Technical Information

To : ICOM Distributors
From : ICOM Inc. / Export Department
Ref No. : SEN-015-03
Date : December 17, 2003

Re. Improvement of the PA Driver for the IC-746PRO/ 7400 series.

Parts Location on the PA board. (L6, L2, R41 and R42)

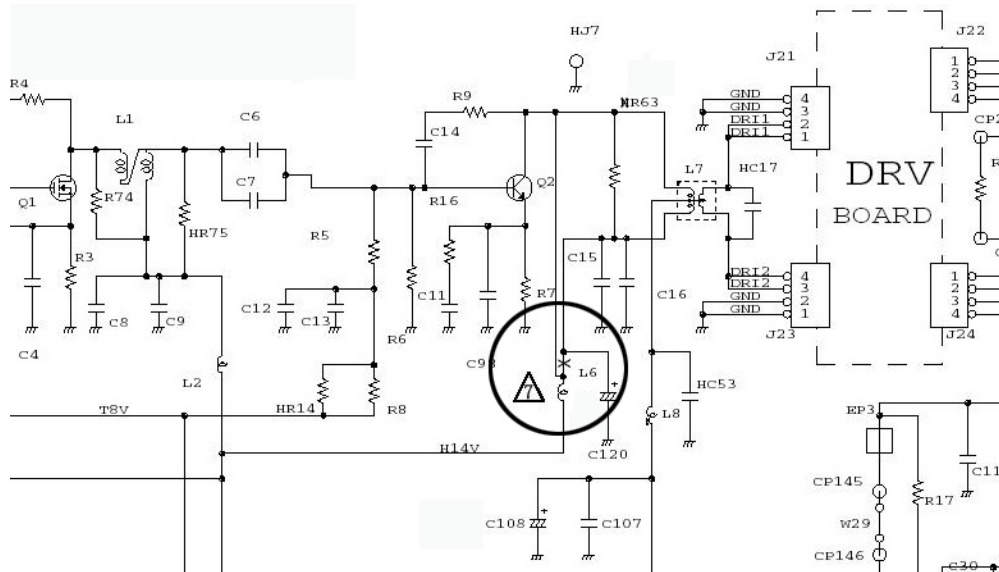
- (1) Replace the parts as shown in the parts list and parts location.
- (2) Replace the MP34 screws which is fixed to the DRV board.
- (3) Adjust PA idling current to 1.5A from 2.5A.

Replace following parts.

Board	Parts Number	Parts Number (Old)	QTY	Parts Number(New)	QTY	Action Taken	Version
CHASSIS	MP34	8810003170	2	8810003370	2	Replaced	All versions
		SCREW(A) 3X8		SCREW(C) 3X8			
PA	L2	620003260	1	6200001830	1	Replaced	All versions
		NL322522T 101J 100U		NL322522T 100J 10U			
PA	L6	2040000490	1	6140002220	1	Replaced	All versions
		EXC-ELDR25C		LR-270			
PA	R41	7030010660	1		0	Removed	#01 only

6.8 ERJ1TY		None			
PA	R41	7030010570	1		0	Removed	#02, 03, 04, 05, 08, 09 and 10 only
		4.7 ERJ1TY		None			
PA	R41		0	7030010660	1	Added	All versions
		None		6.8 ERJ1TY			
PA	R42	7030010660	1		0	Removed	#01 only

Parts Location on the CTRL board. (D25, D26 and R154)

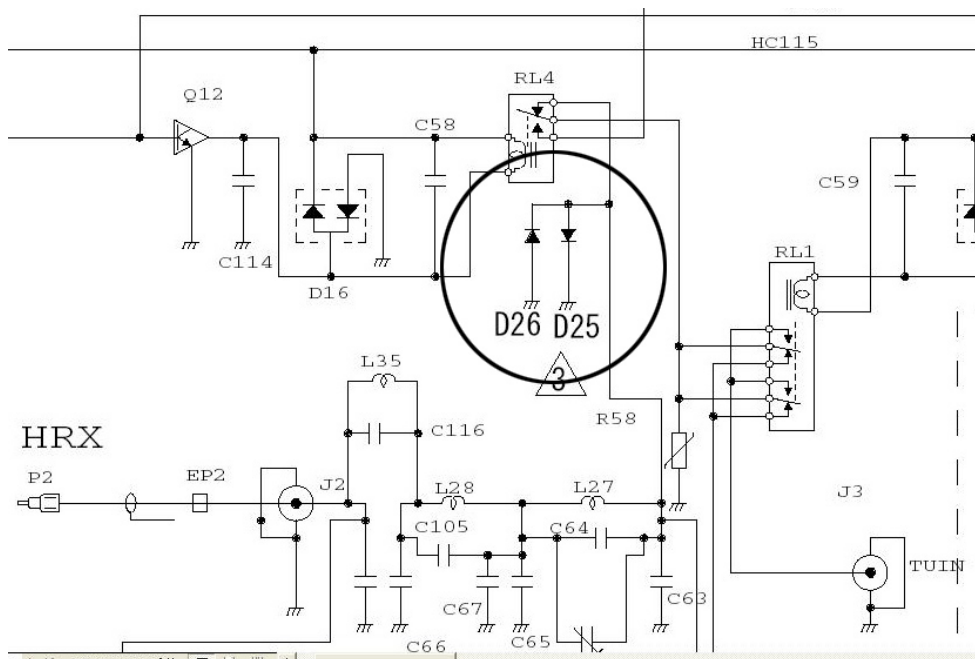
6.8 ERJ1TY		None			
PA	R42	7030010570	1		0	Removed	#02, 03, 04, 05, 08, 09 and 10 only
		4.7 ERJ1TY		None			
PA	R42		0	7030010660	1	Added	All versions
		None		6.8 ERJ1TY			
CTRL	D25		0	1750000810	1	Added	All versions
		None		UM9957			
CTRL	D26		0	1750000810	1	Added	All versions
		None		UM9957			
CTRL	R154	7030003480	1	7030003440	1	Replaced	All versions

Parts Location on the DRV board. (R11)

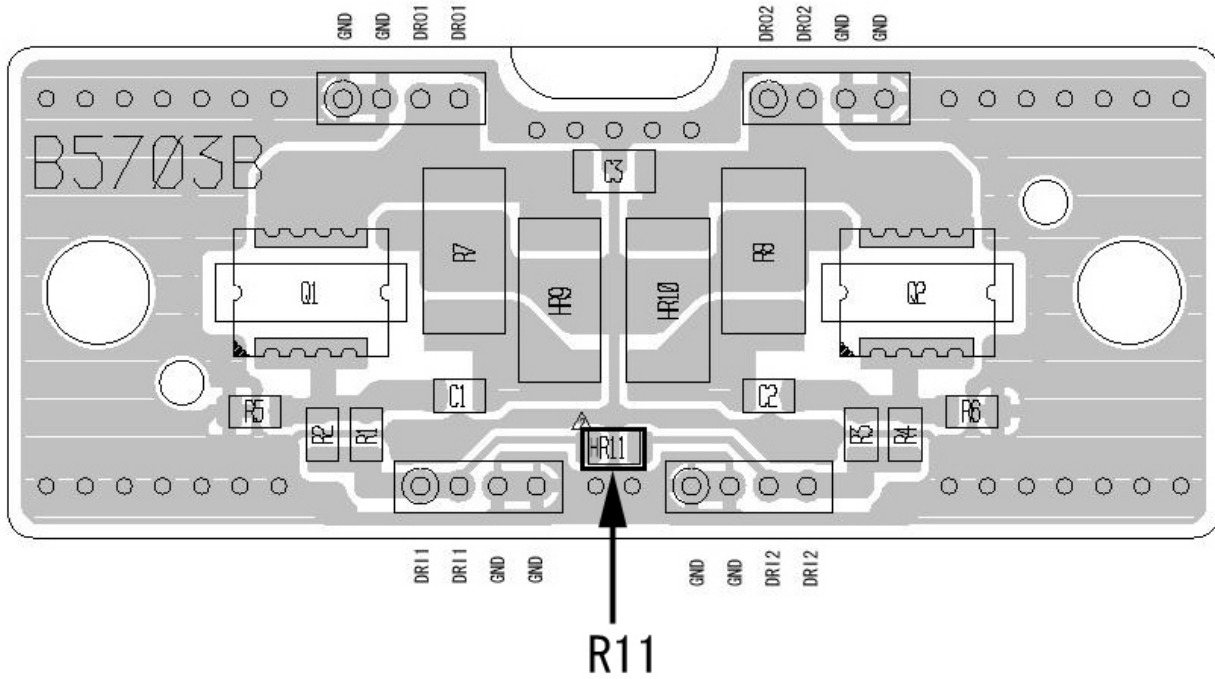
2.2K ERJ3GE		1K ERJ3GE			
DRV	R11	7030000280	1		0	Removed	All versions
		150 MCR10		None
